RE: 498 Spur RPP – March 2022 Amendments

The Cape Elizabeth Land Trust seeks approval to amend the Resource Protection Permit issued in October 2020 for trail bridge and boardwalks at Runaway Farm (498 Spurwink Ave).

# Runaway Farm Proposal

# Runaway Farm (498 Spurwink) Boardwalks Proposal

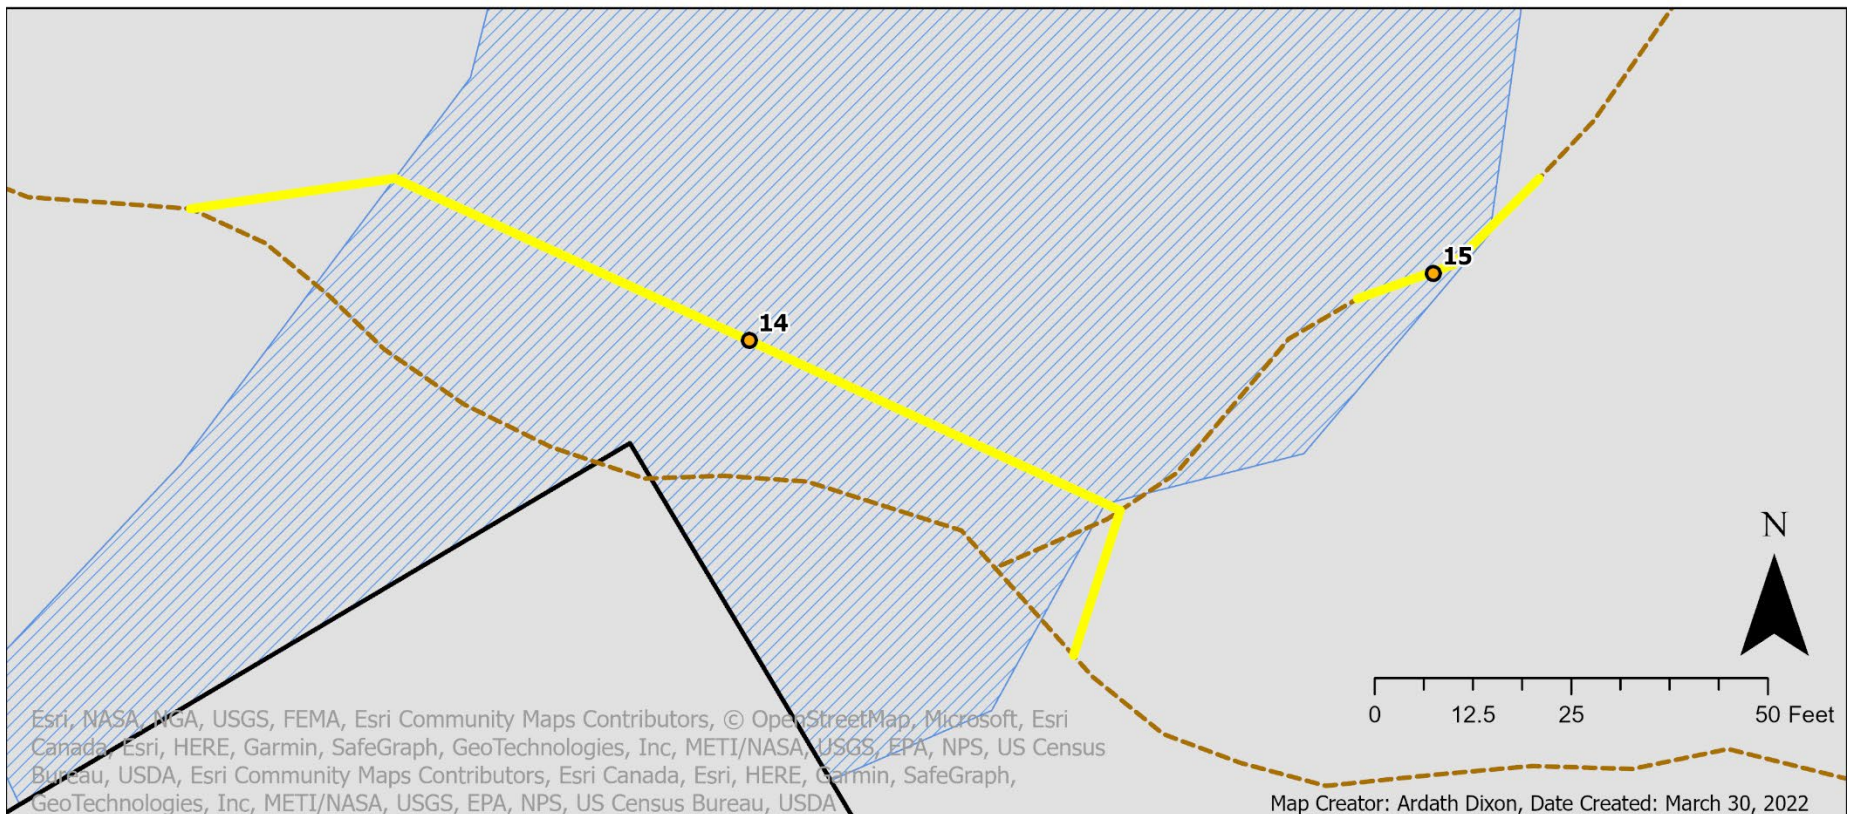
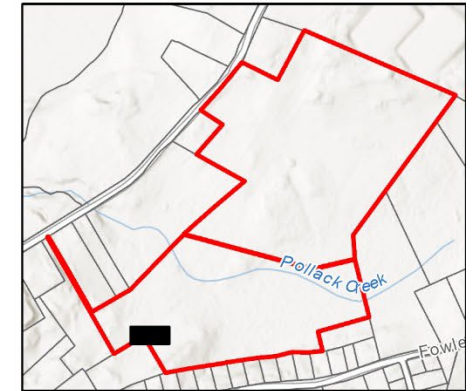
The attached maps now include a third, zoomed in to show more detail for location 1, as requested at the March 8, 2022 Planning Board meeting. They were also updated with new values in the tables, aligning with those shown in the above table.

Location No.	14	15
Length	20 ft new (120 built - 100 removed)	8 ft
Direct Impact Area	20 sq ft new (62 built - 42 removed)	4 sq ft
Indirect Impact Area	88 sq ft new (262 built - 174 removed)	23 sq ft
Total (sum) Impact Areas	108 sq ft new (324 built - 216 removed)	27 sq ft

**Standard Boardwalk Segment  
(variable length)**

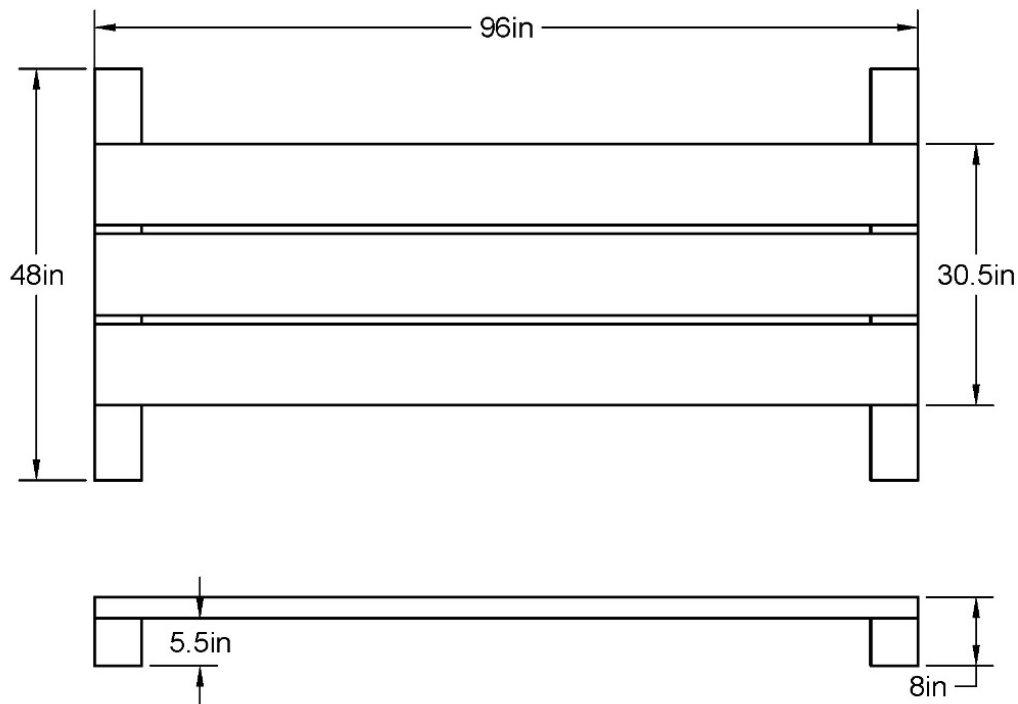
The calculations were also adjusted to assume that sleepers are placed every 4 feet under the runners to permit support where needed, as discussed at the March 8, 2022 Conservation Committee meeting. The impact calculations were made using CELT's Standard Boardwalk Design, which is the same design approved at the October 2020 Planning Board meeting and utilized in earlier phases of the project. The design uses 3" x 10" x variable length runners and 6" x 6" x 4' sleepers (see attached plan).
